DEVELOPMENT APPLICATION ASSESSMENT REPORT

Application Number:	DA2020/1596
----------------------------	-------------

Responsible Officer:	Anne-Marie Young
Land to be developed (Address):	Lot 1 DP 1086858, 6 Mitchell Road PALM BEACH NSW 2108
Proposed Development:	Construction of a dwelling house, including a swimming pool, driveway and garage
Zoning:	E4 Environmental Living RE1 Public Recreation
Development Permissible:	No - Zone RE1 Public Recreation Yes - Zone E4 Environmental Living
Existing Use Rights:	Yes
Consent Authority:	Northern Beaches Council
Delegation Level:	NBLPP
Land and Environment Court Action:	No
Owner:	Roger Keith Bain
Applicant:	Roger Keith Bain

Approved sub-division plan N0824/04. It is noted that the approved plans included reference to a garage below 74.65 AHD

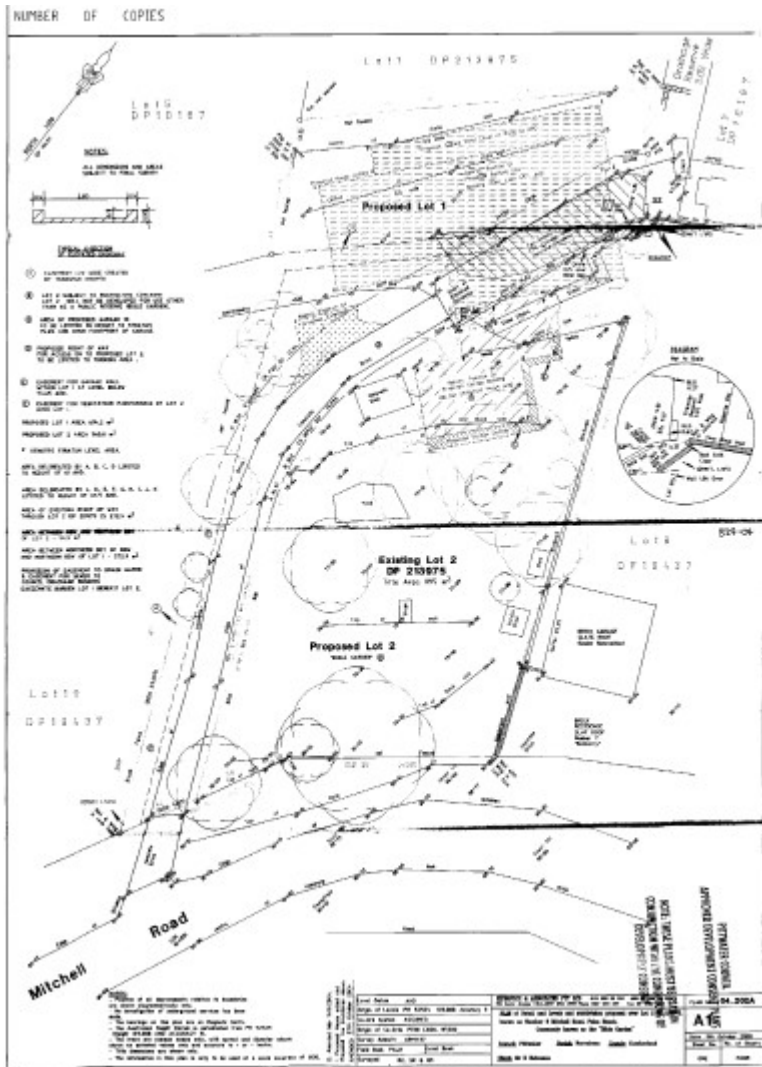
D123 The north west corner of proposed lot 1 is to be reserved for the planting of locally native plants to be undertaken in conjunction with any future residential development on proposed lot 1.

D124 The building platform for proposed lot 1 is to be amended to identify that any dwelling located on the lot must maintain a minimum setback of 4.5m from the rear north western boundary of the site. Details must be provided with the required subdivision certificate.

D131. Any future dwelling erected upon proposed Lot 1 providing private open space between the new dwelling and the rear north western boundary shall limit the finished height of the private open space to a finished height at or below RL 60.5m AHD.

Construction Management Plan (source S Lesiuk)

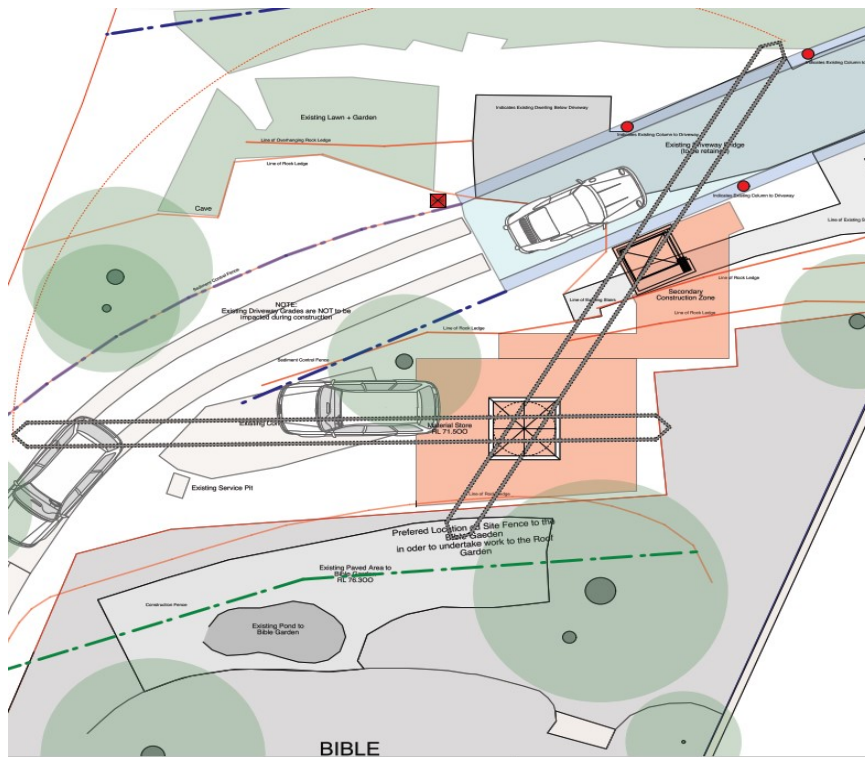
The crane and associated storage are referenced in the Construction Management Plan as being located on the portion of the site, adjacent to the existing concrete parking area, which is within the ownership of the applicant. Although this area is part of the Bible Garden it is sited below the primary accessible area of the Bible Garden at a lower level and is currently not used as public recreation or public access. A portion of the Bible garden will be fenced off during construction (see green dotted line in the plan below) which will result in some loss of access to the Bible garden. This aspect of the development has been considered by Council's Heritage Officer who offer's no objection subject to it being temporary and the restoration of the garden.

Insufficient information has been submitted in terms of the construction of the dwelling to satisfy Council that there will be no unreasonable impacts on pedestrian and vehicular access, refer below.

Section showing the height (source Stephen Lesiuk)

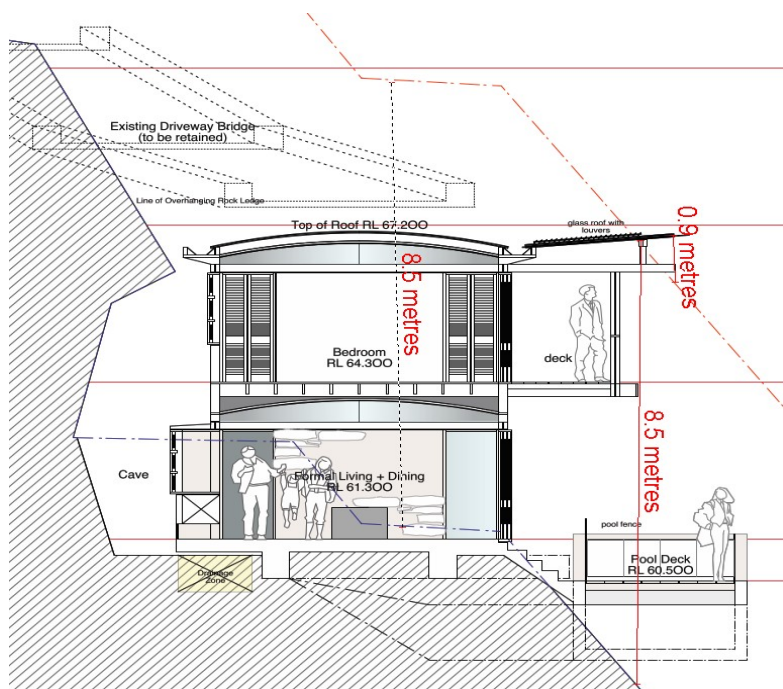
Comment

A small portion of the glass roof over the first floor deck area and a minor portion of the overall building exceeds the 8.5m building height control resulting in a maximum 9.4m building height, refer to image below. The building footprint is located in a slope that is in excess of 16.7 degrees and the minor breach to the height control is acceptable in principle subject to the development being consistent with the objectives of the height control which is discussed in detail below:

Site plan (source Stephen Lusiuk)

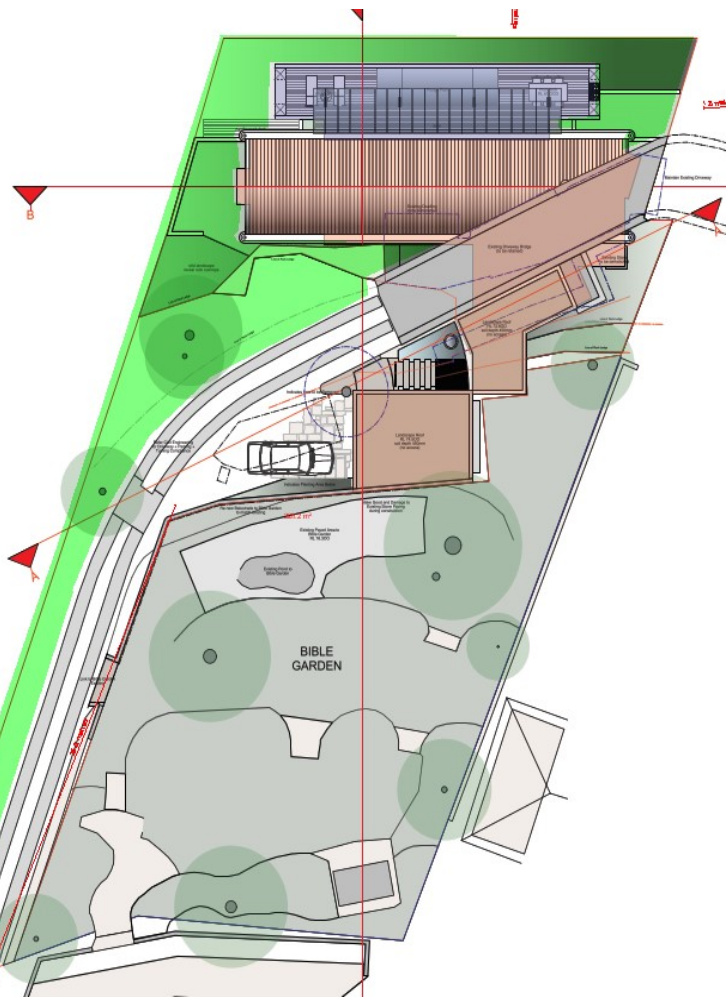
Clause D12.10 requires 60% of the site to be retained as landscaped area. The control allows:

On lots where there is a split zoning and part of the lot is zoned RE1 Public Recreation, E2 Environmental Conservation or SP2 Infrastructure, the calculation for total landscaped area will be based only on that area not zoned RE1 Public Recreation, E2 Environmental Conservation or SP2 Infrastructure. It will not be based on the site area of the whole lot.
